Product Change Notification

Date Issued :	September 14, 2023	PCN Number :	514316
Reason for Change :	Change Supplier		
Description of Change :	Molex's Resin supplier inform Molex that current plant will not produce Valox PBT in the future. To avoid from line down situations either for Molex or for our customers. Molex accepts resin supplier's proposal to qualify their China Nan Sha source material.		
Assessment of Change :	Dimension analysis		
Planned Implementation Date :	March 20, 2024		
Sample Availability Date:	February 28, 2024		
Internal Molex Qualification Date :	March 01, 2024		
Last date to request Samples by Customer :	November 30, 2023		
Traceability Code Markings / Date :	Date code

Before Picture

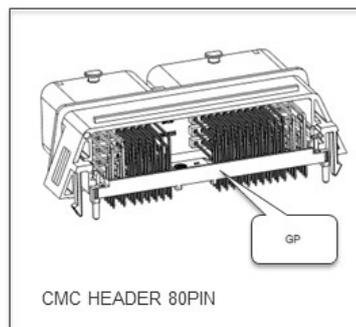
- Before : Shang Hai source material
 - After: Add China Nan Sha source material (Same vendor, same material grade, only manufacture location change)
- **Product Impact**
